Town of Chilmark Squibnocket Beach and Parking Project
Jim O'Connell Brief

March 6, 2014

RE: Evaluation of the Town of Chilmark's 'Squibnocket Beach Access Parking Lot Relocation and Revetment Removal Project'

Fig 5. Parking Lot/Revetment - Coastal Bank Erosion Off-Set

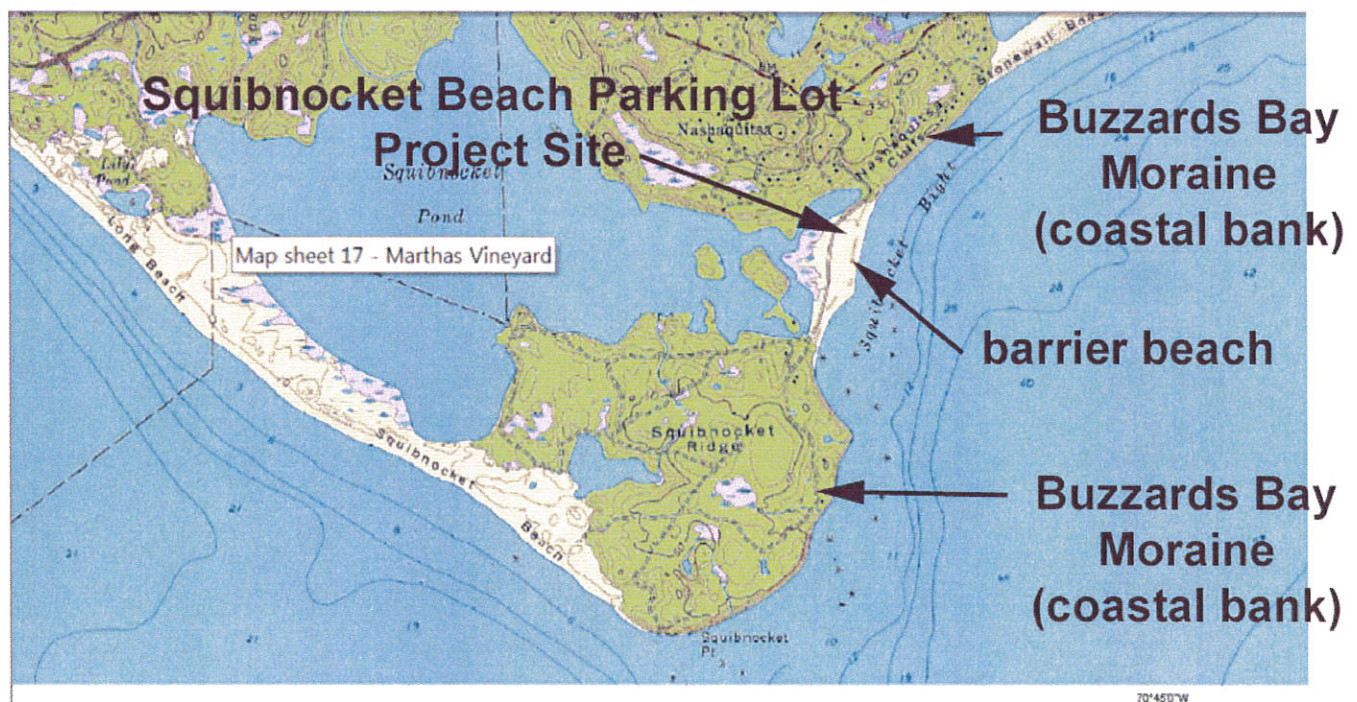
Furthermore, the coastal bank to the east will continue to erode landward (**Figures 4 & 5**), ultimately requiring an extension of the revetment along the east side of Squibnocket Road and the parking lot.

As noted on **Figures 4 & 5**, there is a significant shoreline off-set between the existing beach parking lot and revetment and the adjacent coastal bank to the east due to continuing erosion of the unarmored coastal bank to the east. The parking lot and roadway revetment is in alignment with the coastal bank to the west (Money Hill), except for off-site boulders that were previously placed that are now strewn on the beach fronting the glacial deposit.

Fig 6. Surficial Geology Map

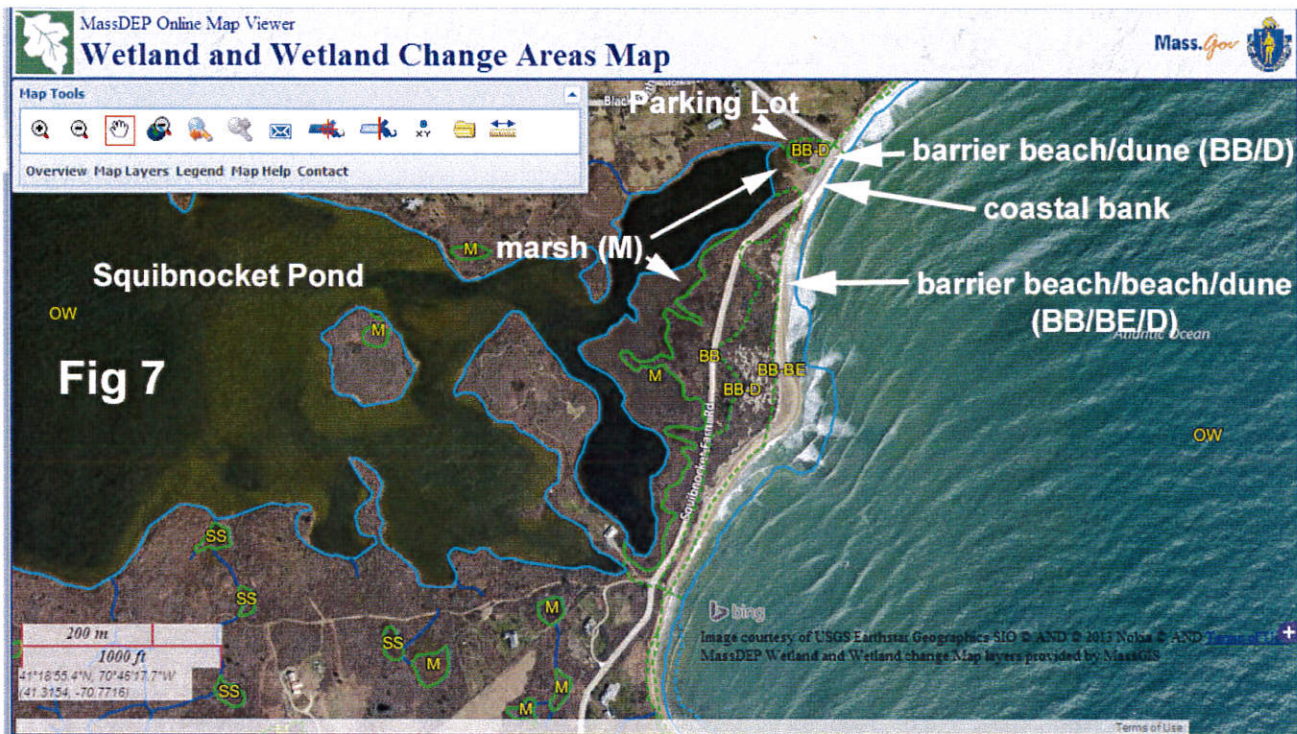
As shown on the *Surficial Geology Map* of Martha's Vineyard compiled by Stone and DiGiacomo, (USGS, 2009) (**Figure 6**) and the *DEP Wetlands and Wetlands Change Map* (**Figure 7**), the site contains portions of the Buzzard Bay/Gay Head Thrust/Squibnocket Moraine

deposits (*green color* on **Figure 8** which are coastal banks), as well as barrier beaches, beaches and dunes (*tan color* on **Figure 8** labeled BB/B/D). The Moraines contain a matrix of till, i.e. boulders, gravel, sand, silt and clay, while the barrier beaches, beaches and dunes consist of cobble, gravel and sand. The site also contains vegetated wetlands landward of the barrier beach (M: marsh). As can be seen on **Figure 7**, two barrier beaches -- one where the existing parking lot is located and the other where the 10.5 acres are located -- are separated by a small glacial deposit (Money Hill: coastal bank).

Fig. 7 DEP Wetlands Map

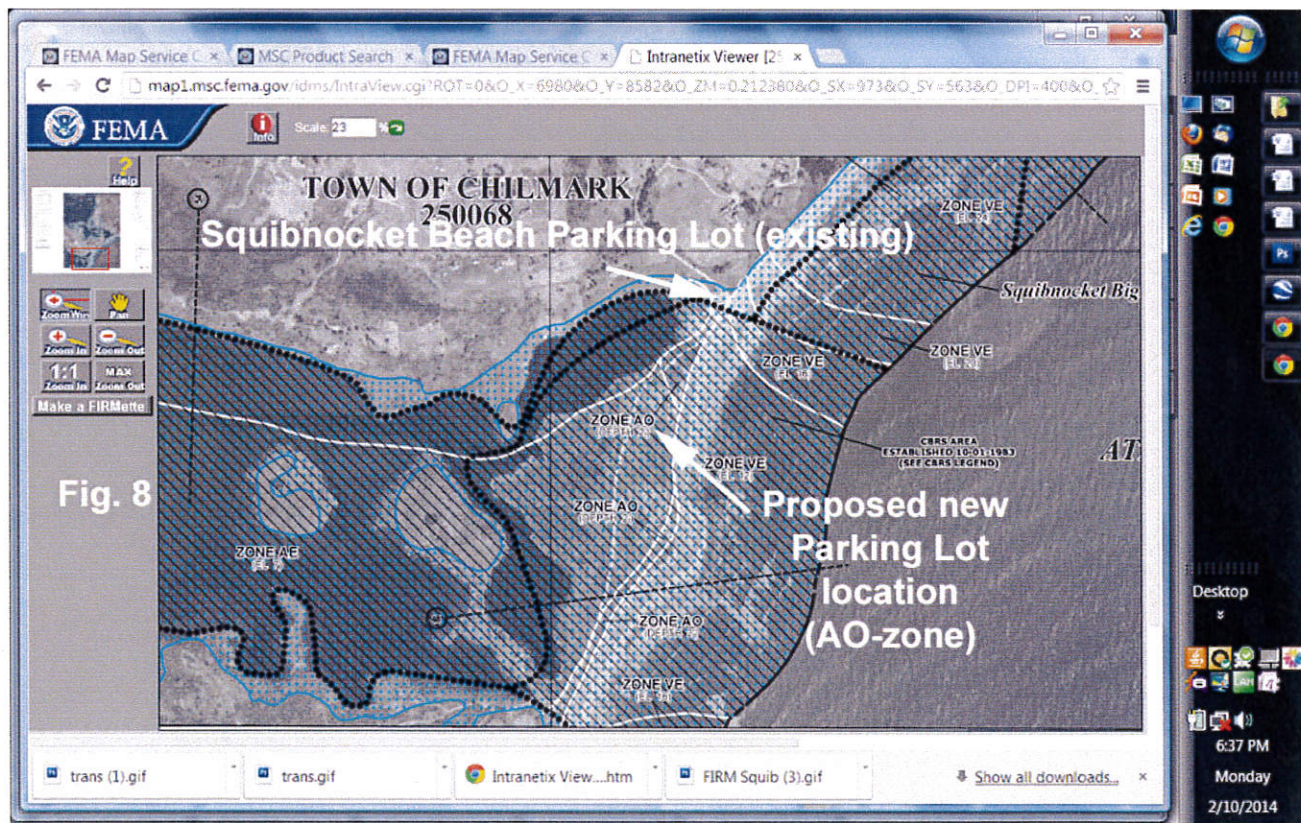
Based on the DEP Wetlands Map, the location of the current parking lot and revetment is a barrier beach, which consists of coastal dune and coastal beach (**Figure XX**). Without the revetment and accompanying fill, the parking lot could not exist: a coastal dune would be in its place.

Fig 8. FEMA Flood Insurance Rate Map

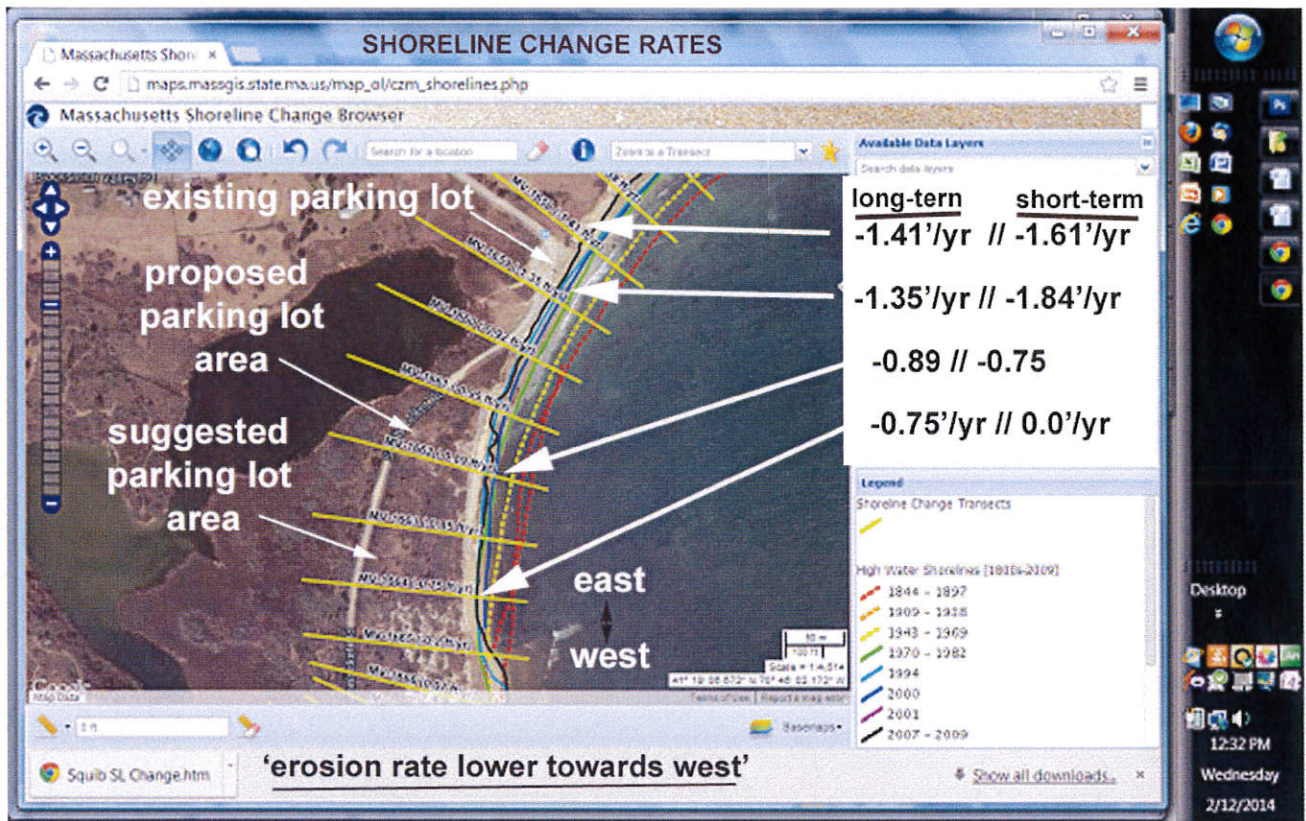
Based on the current legal, Town-adopted FEMA Flood Insurance Rate Map (#25007C0159), published July 6, 2010, the existing parking lot, the proposed parking lot, revetment and beach lie within several different FEMA-mapped flood zones with varying flood elevations (**Figure 8**).

The coastal beach and revetment fronting the existing parking lot on the *east end* are located within a FEMA-mapped Velocity Zone, elevation 16' NAVD, while the beach and revetment located along the *west side* of the existing parking lot are located within a Velocity Zone, elevation 12' NAVD. (*Velocity Zones* are defined as 'areas along coasts subject to a one percent or greater annual chance of flooding in any given year that include additional hazards associated with velocity wave action (3' or greater)).

The beach fronting the *west end* of the existing parking lot, and the entire beach fronting the 10.5 acres proposed to be leased lies within a present FEMA-mapped Velocity Zone, elevation 12' NAVD.

The *existing parking lot*, as well as the proposed location of the new parking lot are located within a FEMA-mapped *AO Zone*, depth 2'. (*AO-zones* are defined as 'areas subject to a one percent or greater annual chance of shallow flooding in any given year. Flooding is usually in the form of sheet flow ('overwash' in coastal areas) with average depths between 1 and 3 feet.)

At the present time, the proposed parking lot is located within a FEMA-mapped AO-Zone (**Figure 8**). The Velocity-/AO-Zone line is located at the seaward edge of dune vegetation.

Fig 11. Existing, Proposed and Suggested Squibnocket Beach Parking Lot Locations

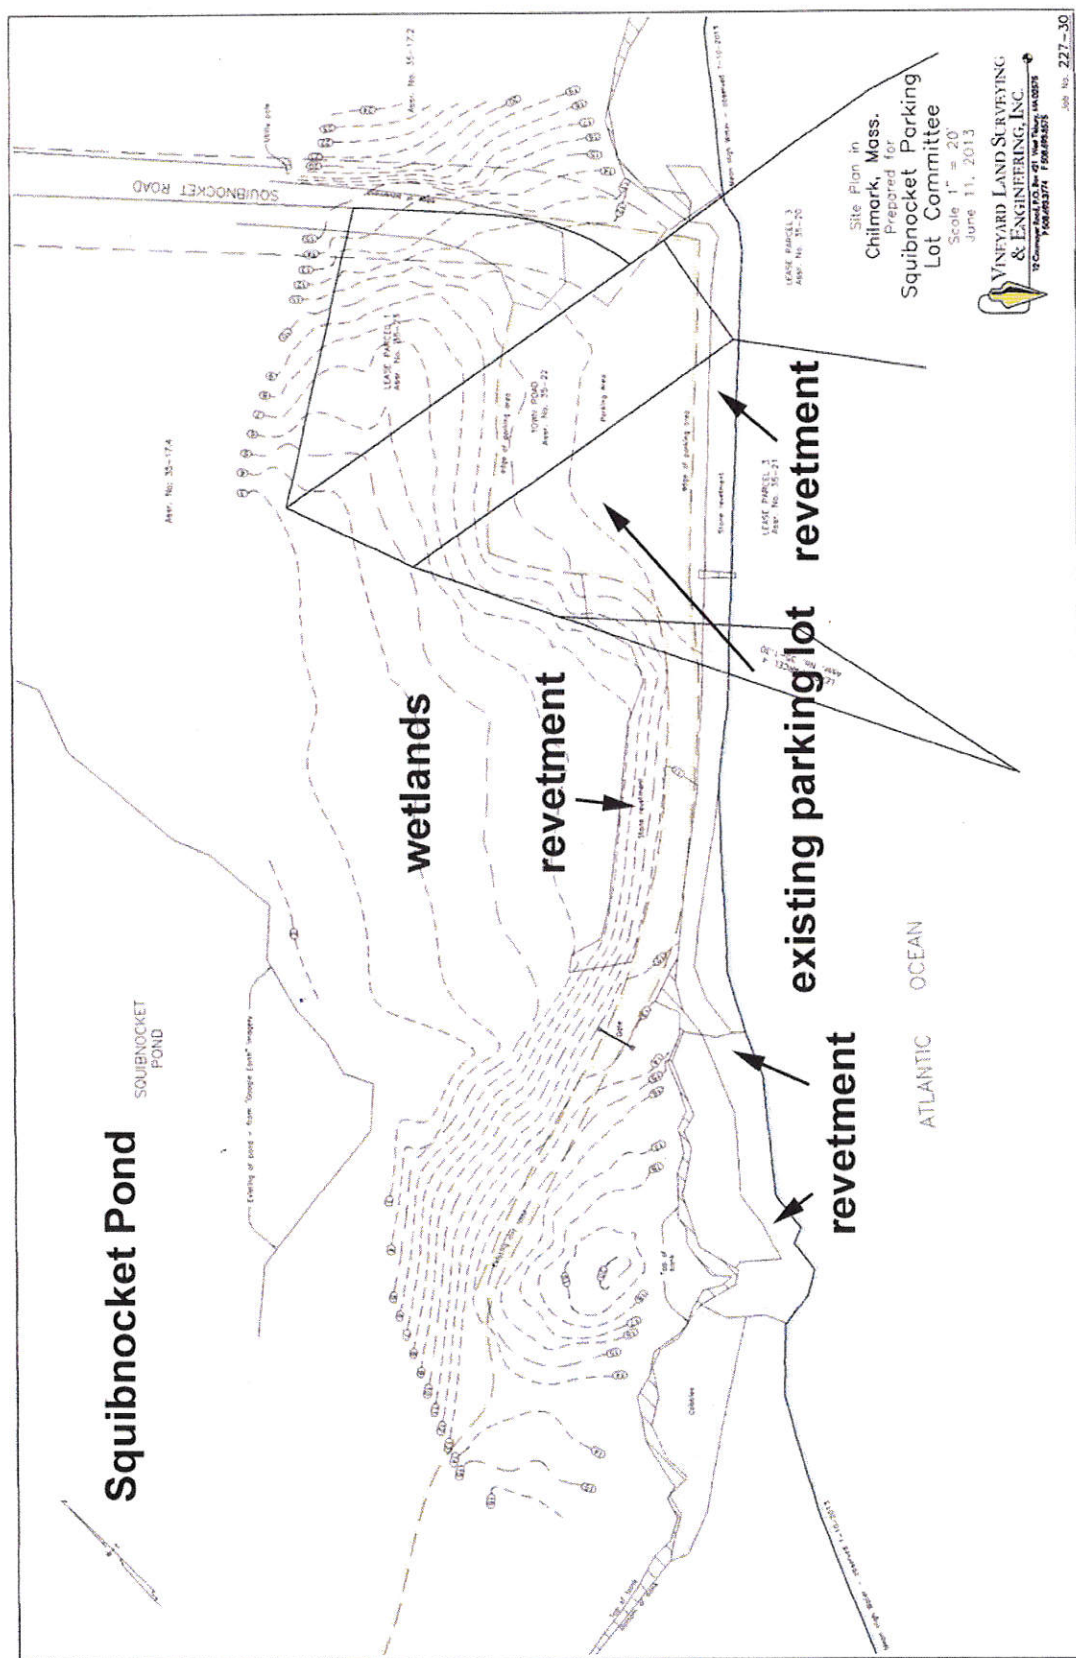
Thus, it is suggested to consider locating the new proposed parking area along Squibnocket Road landward of the cobble lag deposit, slightly to the west of the *proposed* location (see 'suggested' location on Figure 11). The benefits of this location to consider are:

1. the storm, erosion and overwash protection provided to the area by the cobble lag deposit;
2. this location may provide a slightly greater distance between the lot and the presently mapped FEMA Velocity Zone possibly less frequent overwash and storm water inundation which will provide a bit more longevity and less frequent maintenance;
3. dense vegetation exists between this site and the active beach which will reduce overwash material reaching the parking area location; and,
4. it was noted that higher trees and shrubs exist on the Squibnocket Pond (north) side of the roadway that may provide a greater vista buffer for houses on the slope west of the Pond.

As suggested above, moving the proposed parking area slightly to the west (see Figure 11) will provide a bit more longevity and lower frequency of overwash to this suggested parking area. The swath of salt-tolerant dune vegetation is greater in this suggested location than the presently proposed parking area. Salt-tolerant dune vegetation will diminish with on-going erosion and landward movement of the high water line; however, following coastal storms and overwash salt-tolerant dune vegetation usually re-establishes itself naturally shortly following coastal storms.

*It is suggested that a discussion locating the new proposed beach access parking lot a bit more to the west than presently plotted on the proposed Plan, along the side of the roadway landward of the cobble lag deposit be considered (labeled 'suggested' new parking lot area on Figure 11). The seaward cobble lag deposit will provide additional protection and longevity to a new parking lot relative to chronic erosion and overwash compared to the location presently plotted on the proposed plan: the present proposed location of a new parking lot is located landward of an overwash area (**Figure 10**).*

Although the location for the new lot on the existing proposed plan may last approximately 160 years based on current erosion rates as described above (and less years considering relative sea level rise), moving it a bit to the west will provide additional longevity as the documented erosion rates are less to the west and the cobble lag deposit will provide additional erosion and overwash protection.

The beach access pathway from the new parking lot could be orientated south towards the beach and then be angled to the south-southeast in order to avoid overwash potential in the new pedestrian path (see **Figure 11**).

Fig 12. Topographic Survey Squibnocket Beach Parking Lot Area (Vineyard Surveying)

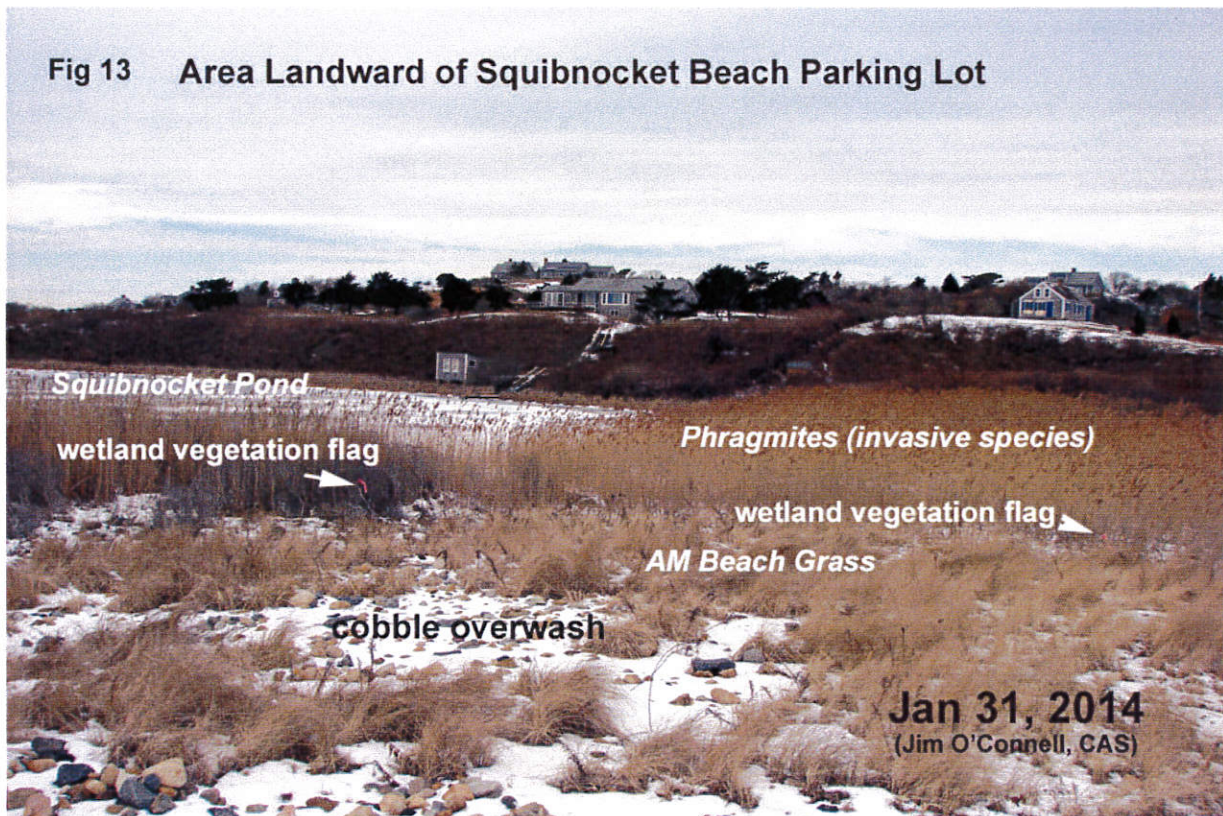
As noted on the Vineyard Surveying and Engineering existing topographic site plan (**Figure 12**), the parking lot is much higher in elevation than the landward and adjacent area between Squibnocket Pond and the parking lot and armored roadway.

With the parking lot and revetment removed the area will be significantly lowered in elevation allowing frequent storm waves and overwash deposits to cascade through the area into Squibnocket Pond (see **Figures 3 and 12**).

Fig 13. Area Landward of Parking Lot (overwash & wetlands)

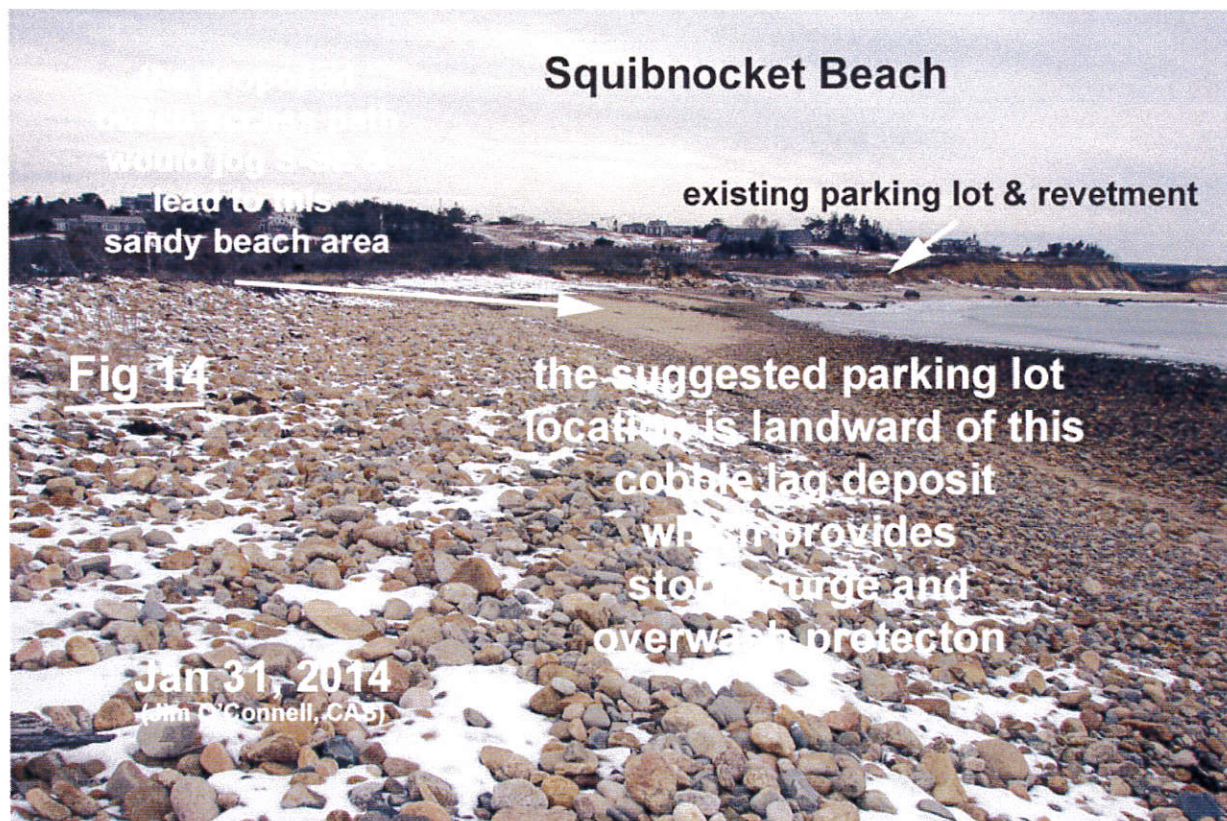
Vegetated wetlands exist between the parking lot and the Pond indicative of saturated soils, as well as AM Beach Grass (**Figure 13**). Invasive *Phragmites* is also present in this area. Overwash deposits (cobble) have also been deposited in this area between the existing parking lot and the Pond, indicative of the high storm wave and surge energy along this reach of shore (**Figure 13**).

Fig 14. Cobble Beach Deposit & Sandy Beach Acces Point
(Jim O'Connell, Coastal Advisory Services)

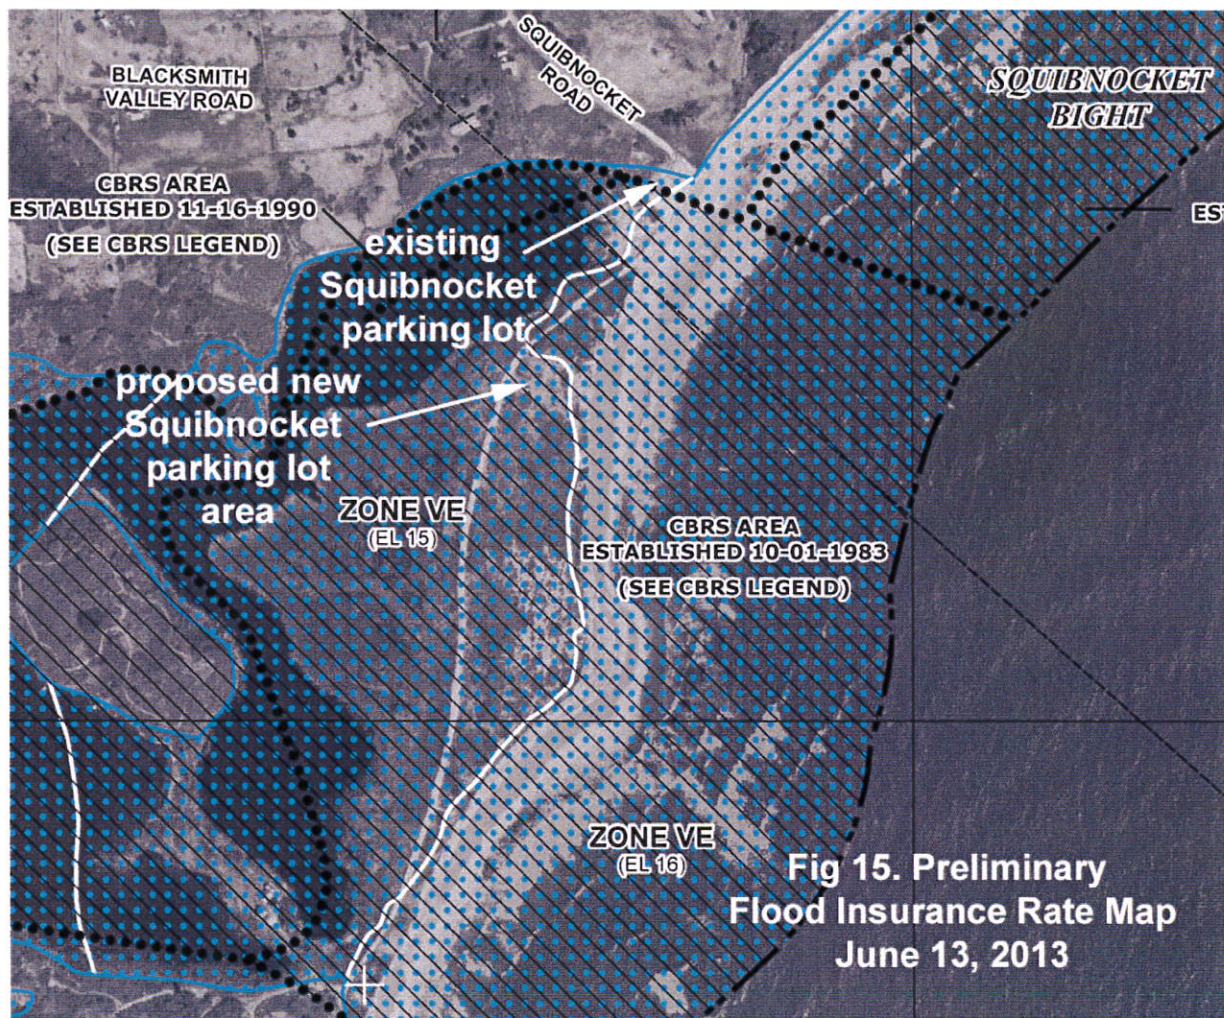
In considering this suggested location (or the existing proposed location), it is also suggested that the pedestrian beach access pathway from the lot to the beach be angled slightly to the southeast away from the prevailing wave direction. This may reduce the potential of the pedestrian beach access pathway becoming a sluiceway for overwash sediment, and will also allow beach goers to enter the beach in an area with fewer cobbles and denser sandy deposits (Figures 11 & 14).

*A consultant alternative location for the beach access parking lot that may provide enhanced longevity is suggested for discussion as shown on **Figure 11**, with the access leading to the beach shown on **Figure 14**.*
